# SERVICE BULLETIN

PURPOSE : INFORMATION	ISSUE NO. : MSB-12EXML42-002	DATE : 2012-9-20
SUBJECT : ADJUSTMENT OF DOOR STRIKER FOR THE VEHICLES WITH SIDE-CURTAIN AIRBAGS	<Destination/Model> (ALL DESTINATIONS) <M/Y> ALL	
GROUP : BODY	THE VEHICLES WITH THE SIDE-CURTAIN AIRBAGS

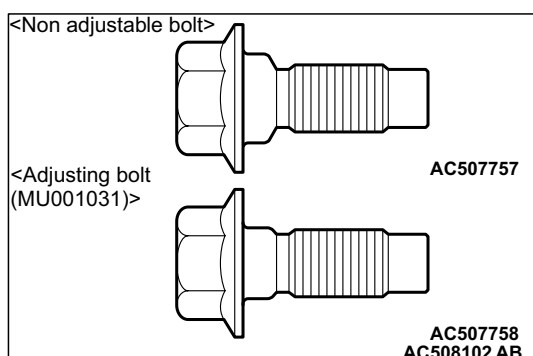
(2) Move the door to adjust so that the door is flush with the body surface.

(3) If adjustment is not possible, replace the door-side door hinge mounting bolt with the adjustment bolt (MU001031).

*NOTE: If the adjustment bolt has been already installed, reuse it.*

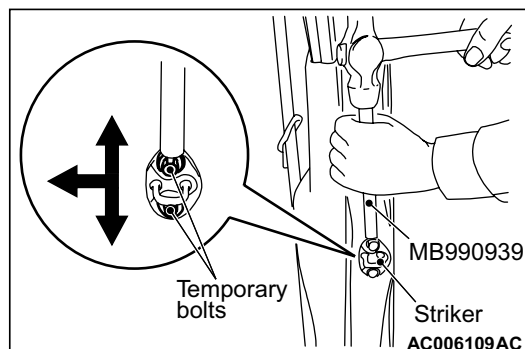
(4) Move the door to adjust so that the door is flush with the body surface.

(5) Tighten the door-side door hinge mounting bolt to the specified torque.

**Tightening torque:  $26 \pm 6$  N·m**

(1) Adjustment using the striker (toward the inside of the vehicle and vertical direction):

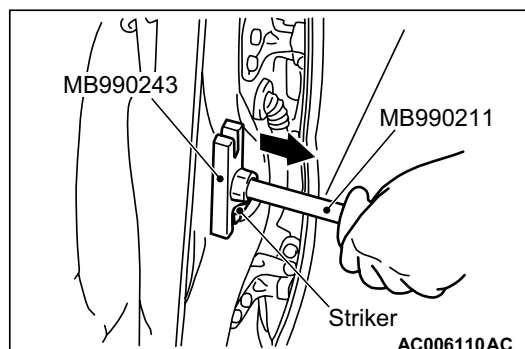
To adjust the striker, always turn the ignition switch to "LOCK" (OFF).

Install a temporary bolt instead of the striker mounting bolt, and use the remover bar (Special tool: MB990939) and a hammer to tap the temporary bolt to the desired direction.

(2) Adjustment by using the striker (toward the outside of the vehicle):

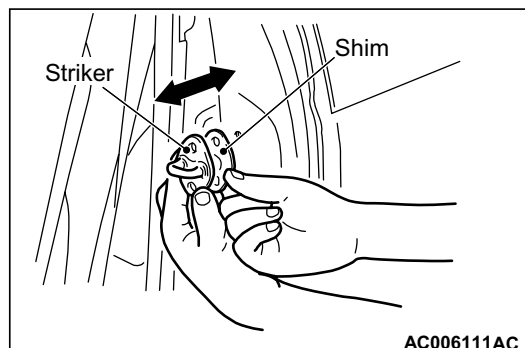
Using the following tools, pull the striker toward the outside of the vehicle to adjust.

- Slide hammer (MB990211)
- Body puller (MB990243)
